Docket Item # 8 & #9 BAR
CASE # 2016-00263 &
2016-00264

BAR Meeting
September 7, 2016

ISSUE: Permit to Demolish and Certificate of Appropriateness for Alterations

LOCATION: 716 Queen Street

Figure 1: The applicant's preferred initial scheme. Note the addition of a central window to the second story.

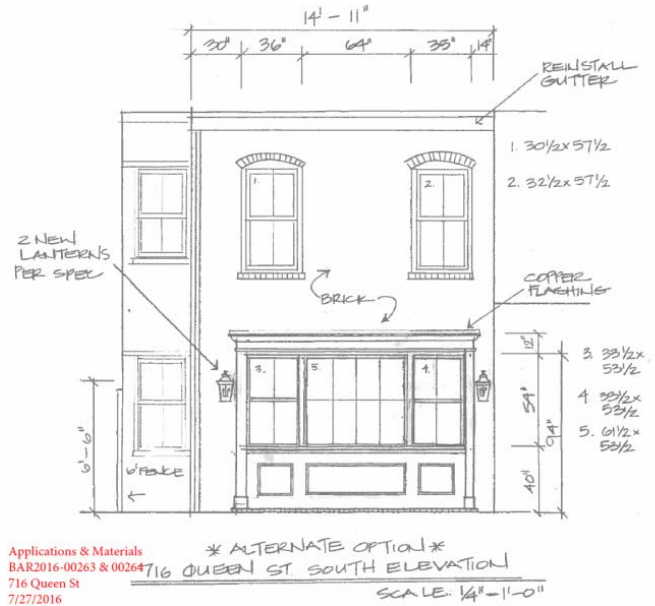
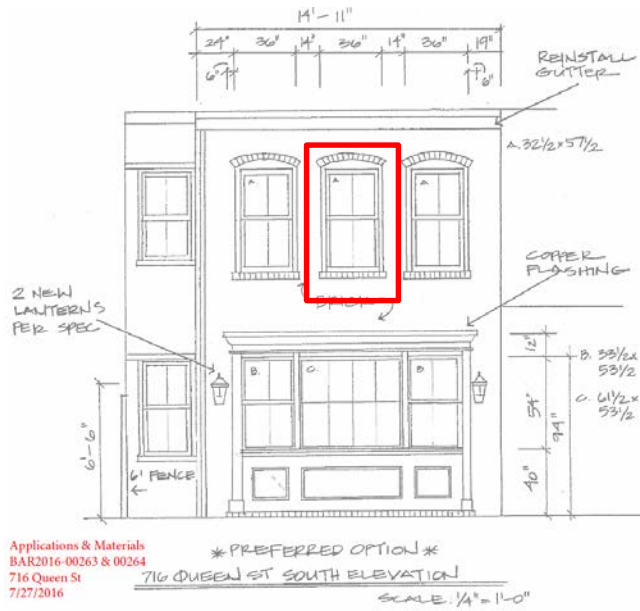
The applicant’s design for the altered elevation has evolved since speaking with BAR Staff. Originally, the applicant desired the addition of a third, centralized window between the two existing windows on the second story (Figure 1). This would have necessitated moving the apertures of the original two windows farther apart in order to achieve symmetry. The applicant, however, also provided an alternative design in her original submission that left the second-floor portion fenestration intact (Figure 2). Because this upper portion of the elevation is visible from the Lloyd House garden, and because adding a third window to a two-bay elevation would be unconventional, staff advised the applicant to choose the alternate scheme.

The applicant’s latest submission (Figure 5) keeps the second-floor portion’s fenestration pattern as it currently is. The BAR has noted in previous projects that where a row of historic ells remain relatively unaltered and are visible from the public way, it is preferable to retain as much of the material, form and design as possible in order to convey these historic secondary spaces. Since the majority of the adjoining townhomes on Queen Street have unaltered rear elevations, it is preferable to keep the visible second-story elevation on this dwelling intact as well.

3. The segmental arch forms above the two second-story windows must be reconstructed to match the size and location of the two original window openings.

Figure 3: The applicant's first-floor fenestration pattern associative image, former submission.

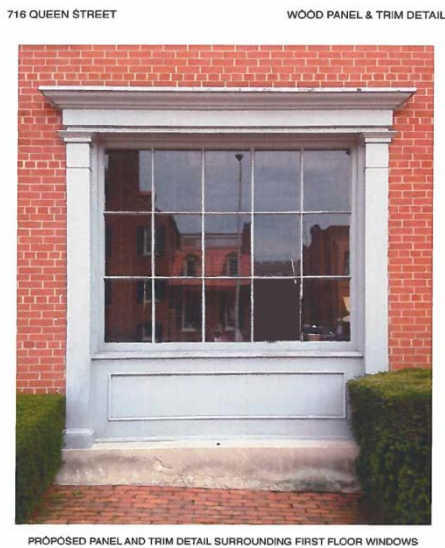
In regards to the first-floor, the applicant originally wished to alter the current fenestration by replacing the two segmental arch apertures with a large, multi-light window with wood trim, including pilasters, architrave, and panels (Figures 1 and 2). The applicant's associative image, included in her original submission, was a storefront window found at a local bank (Figure 3). Her inspiration was a modern, industrial curtain wall incised into a historic townhome (Figure 4).

Figure 5: The applicant's preferred scheme for first-floor fenestration. current submission.

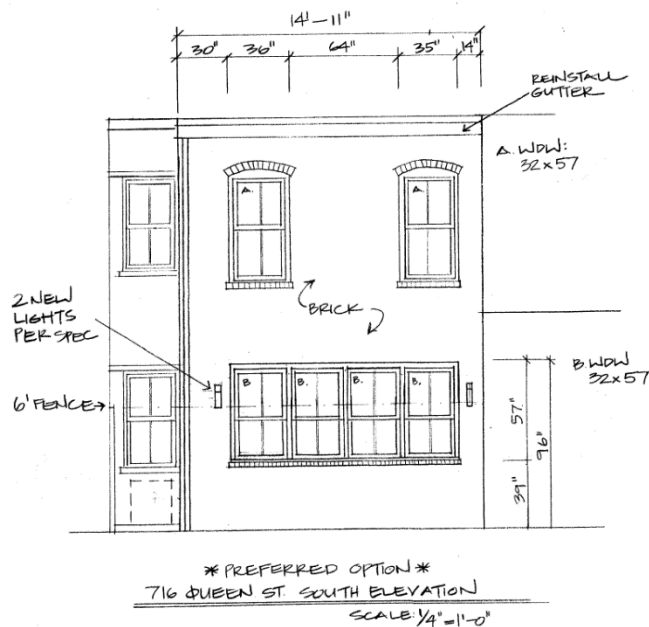
If the applicant’s alternate option is the most conservative approach to this design query and the industrial curtain wall (Figure 4) which inspired the applicant could be said to be the most radical approach, there is a middle ground found in the applicant’s preferred option (Figure 5). This is also a more elegant and simple solution than her original submission with Colonial Revival style trim, and this fenestration pattern potentially maximizes the amount of daylighting while retaining a larger portion of the historic masonry (Figure 5). Here, the applicant has eradicated the segmental arch forms yet kept the brick row-lock which visually connects the window sill with the upper-story sills. The applicant has created a continuous span across the majority of the elevation’s width by ganging four two-over-two double-hung windows in a late-Victorian style. The aperture height is maintained, as is the historic sash light configuration, while the end windows vertically align with the upper-story apertures.

However, the preferred alternative in Figure 5 lacks any visual structural support above the windows. A brick jack arch is stylistically inappropriate and would not structurally span this width. This lintel is an important feature, as it is the primary element that will be visible above the fence. A flush wood lintel, a minimum 8” tall, would be appropriate. Staff also suggests that the applicant consider a steel, C-channel lintel for this window span, which would add a visual demarcation to the aperture as well as allude to the applicant’s industrial inspiration. The successful use of such metal lintels on a historic structure can be seen at 210 North Lee Street (Figure 6).

1. Approval of the Permit to Demolish.
2. Approval of either the applicant's preferred option or the alternate option for the first floor windows, as directed by the BAR at the hearing. If the applicant's preferred option is selected, the windows must have a wood or metal lintel with final details to be reviewed by staff prior to release of a building permit.

REAR WALL (SOUTH ELEVATION)

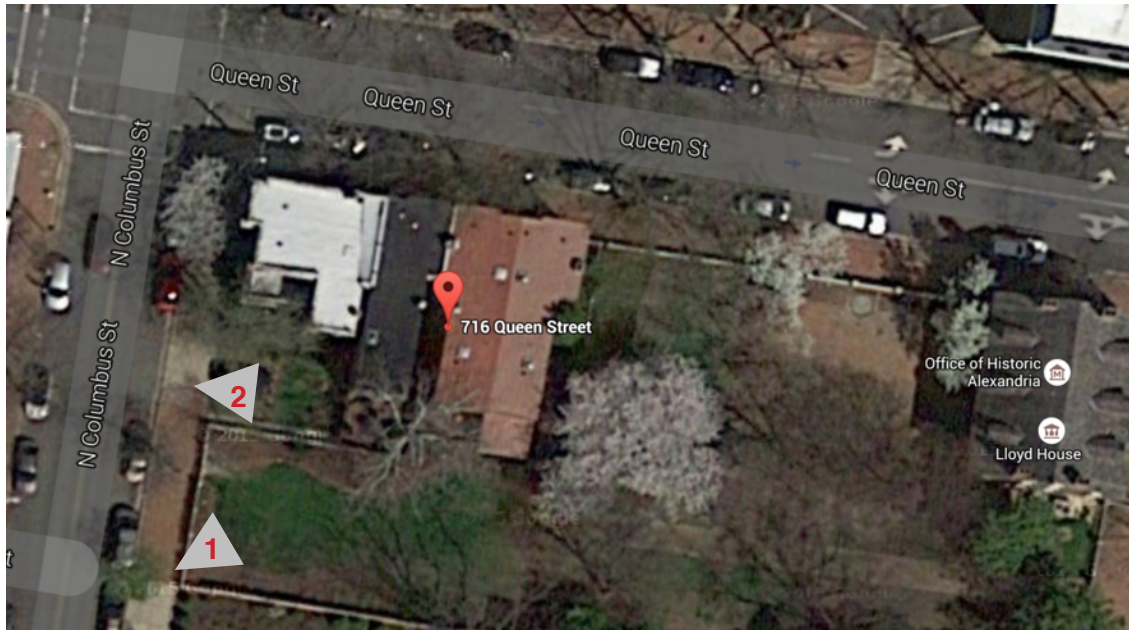
Although the BARs “prefer the amount of demolition be limited to that necessary... rather than wholesale demolition and replacement of the rear façade,” BARs do take into account compelling reasons for demolition, such as lack of structural integrity. Staff recommends that the applicant retain and preserve in place as much of the upper south wall and its materials as possible. However, as water damage and deferred maintenance have resulted in its severe deterioration, to the point of it becoming structurally unsound, staff supports carefully dismantling the historic rear wall as necessary.

Staff also supports the applicant’s intent to rebuild the wall using salvaged and historic bricks with lime putty mortar. Whereas the BARs routinely permit partial demolitions or encapsulations of rear walls for additions, this project will largely reconstruct the historic fabric and leave it exposed, thereby retaining the house’s form and footprint and building materials intact and visible. Staff recommends that the mason replicate the existing 7:1 common bond pattern that distinguishes the rear elevation.

5. The applicant will retain as much of the original brick as possible and use bricks salvaged from the deconstruction of the south elevation to reconstruct the southern (rear) wall; if historic bricks are acquired from another source, they must match the existing historic bricks in color, size, and texture.

6. The mason will provide a mock-up sample of hydraulic lime mortar which matches the original mortar in color, tooling and composition. The mock-up must be approved by BAR Staff on site prior to commencement of work.

* PREFERRED OPTION *
 716 QUEEN ST. SOUTH ELEVATION

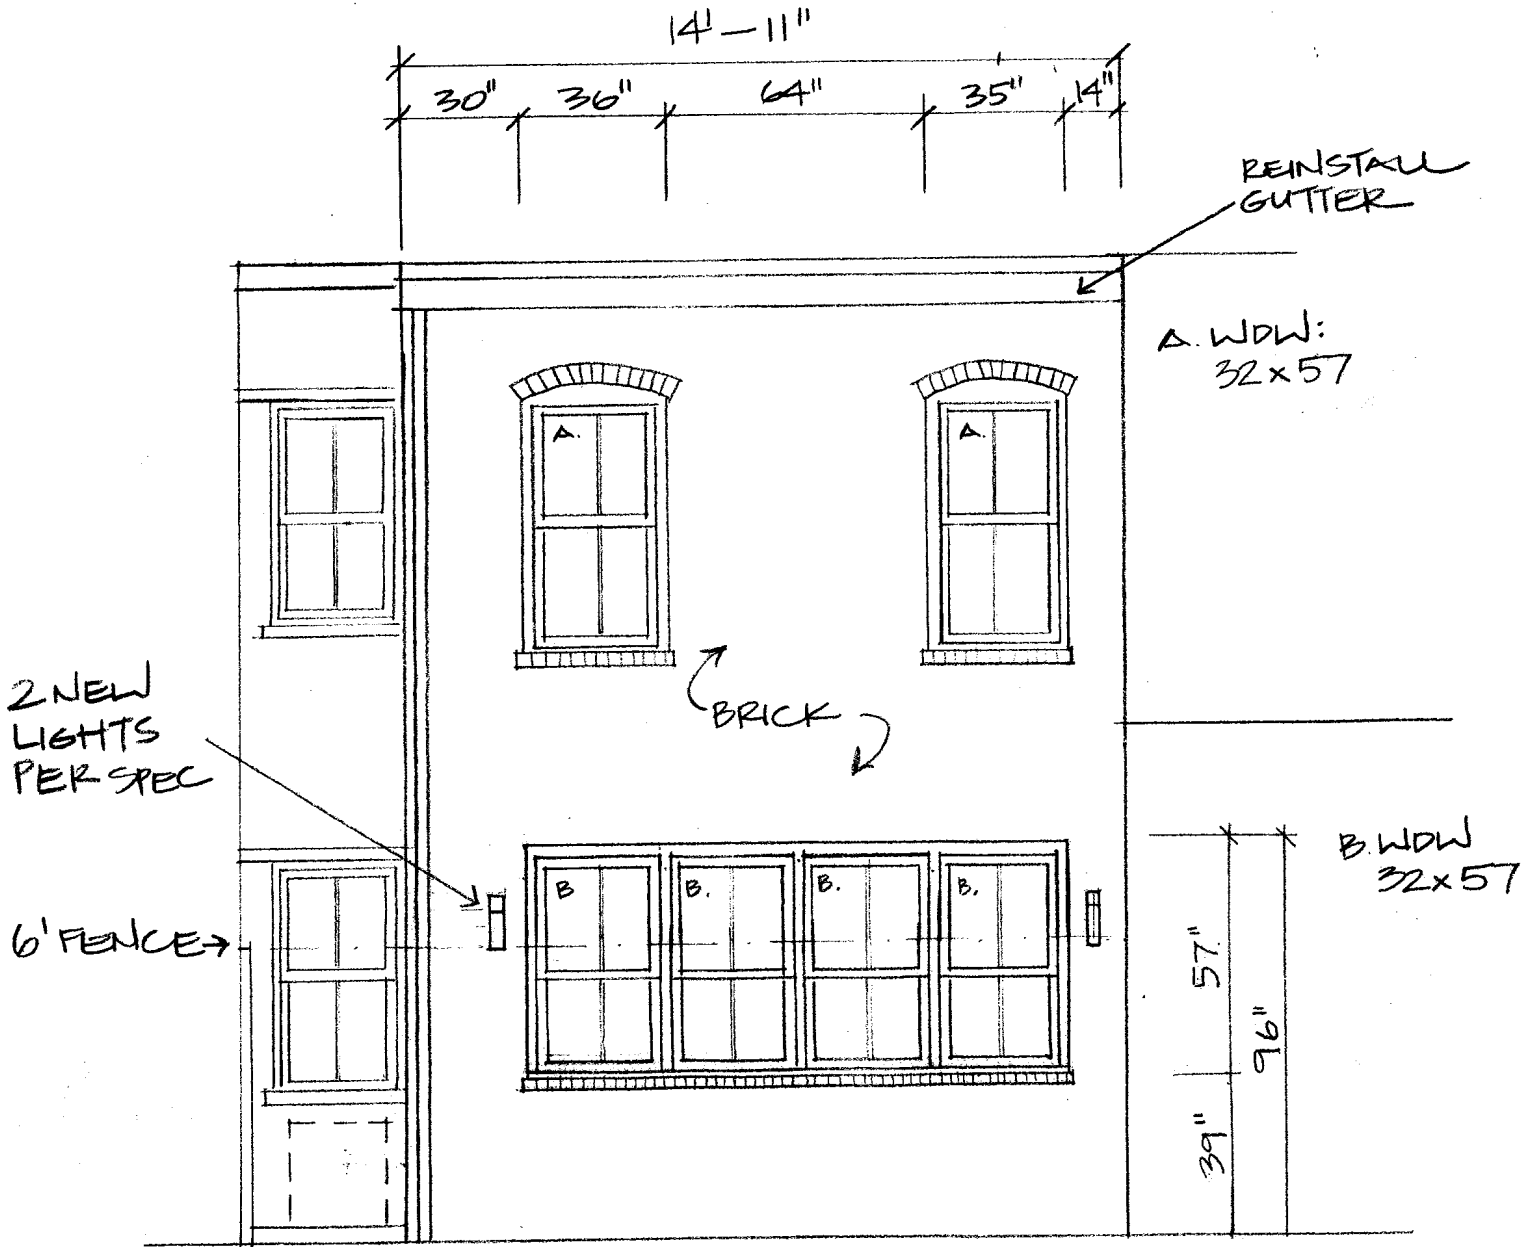
scheme is adopted, then staff further recommends that the four new windows on the first floor also be wood, double-hung, two-over-two light windows. Similarly, if the alternate scheme is adopted, staff recommends that all three new windows match the upper-story replacements.

4. The two existing second-story windows on the southern elevation must be replaced with painted wood windows. All replacement and new windows must meet the Alexandria Replacement Window Performance Specifications contained in the BAR's adopted window policy.

* ALTERNATE OPTION *

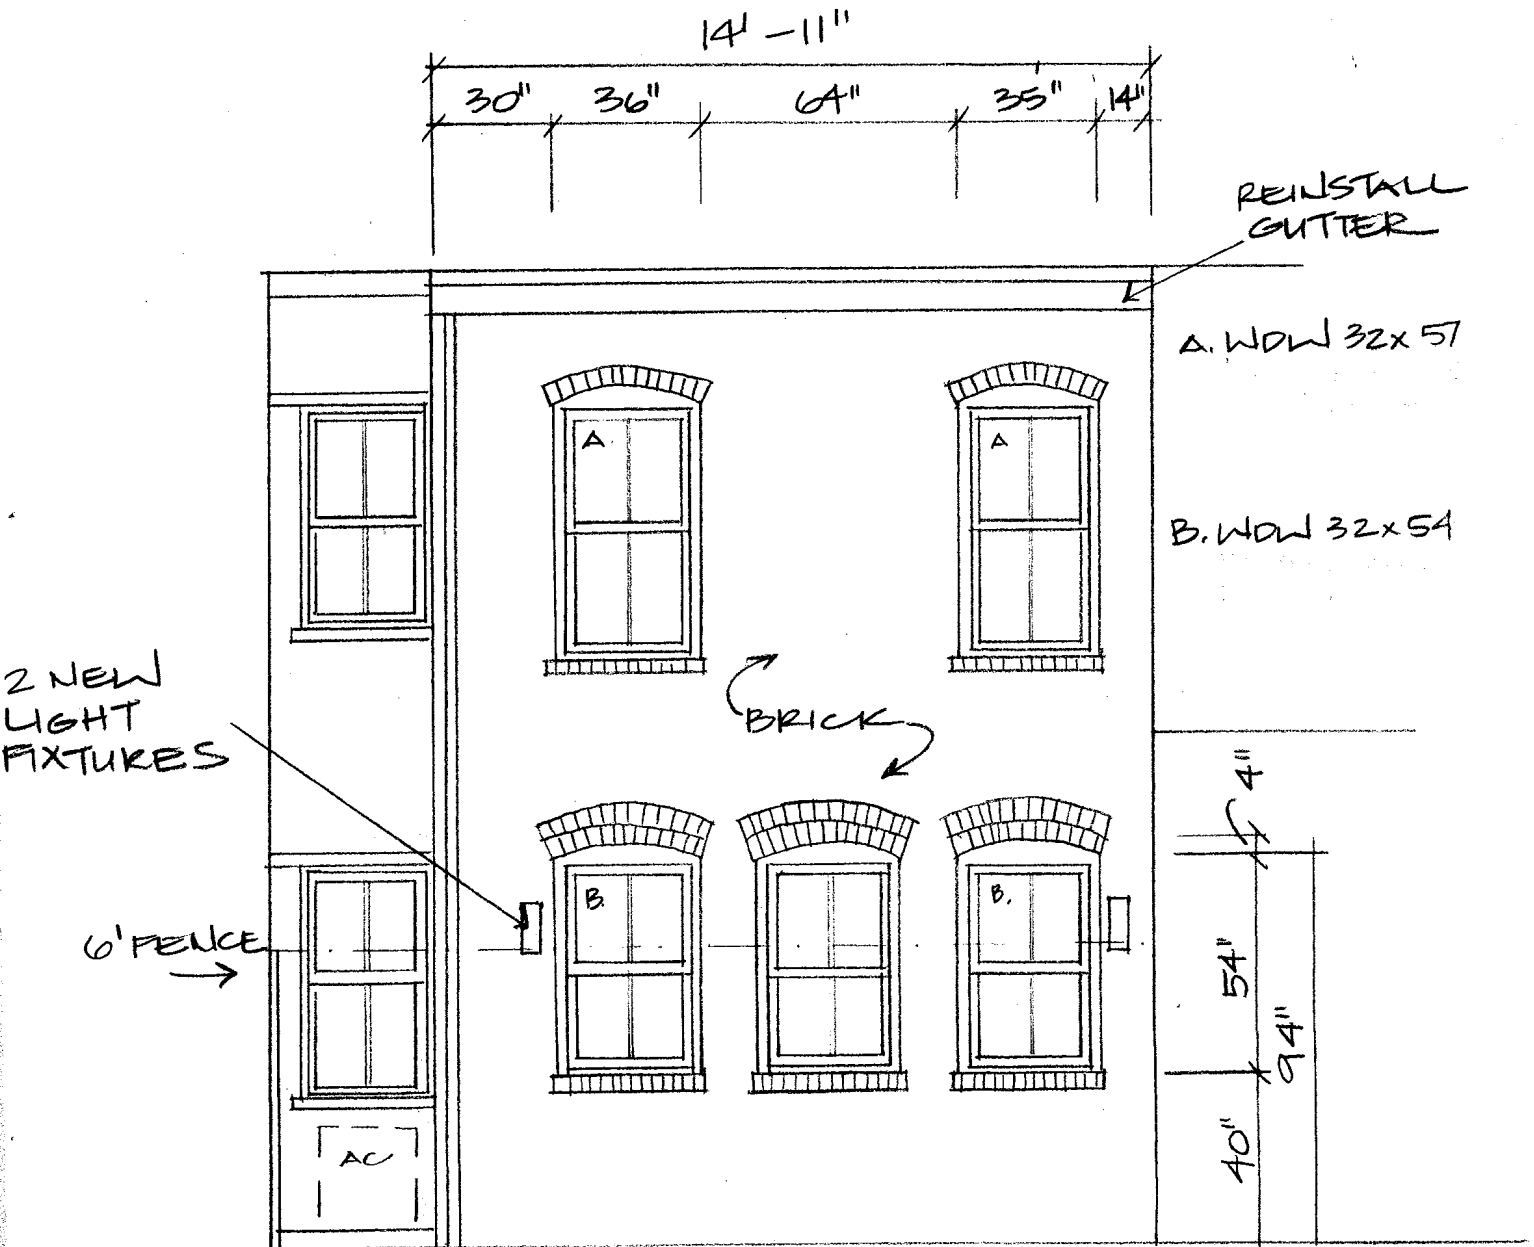
While the applicant's alternate option – in which a central window is inserted between the two existing apertures on the first floor – is less intrusive and repeats the historical window forms, logic maintains that an addition of a third window into a two-bay elevation on the ground floor is just as awkward as it would be if a similar window were inserted on the upper floor (see Figure 1). Furthermore, the mimicry of a historic form may confuse future “readings” of the building's evolution; in other words, persons seeing an elevation in which the bottom floor has three sequential apertures with double-course segmental arches might justly but incorrectly assume that the fenestration pattern is original. In the *Secretary of Interior's Standards for Rehabilitation*, standard #3 states that “Each property will be recognized as a physical record of its time, place, and use. Changes that create a false sense of historical development... will not be undertaken,” while standard #9 succinctly advises that “New additions, exterior alterations, or

related new construction... will be differentiated from the old and will be compatible.”² The repetition of a third window with an historic arch form would visually blur the line between authenticity and alteration.
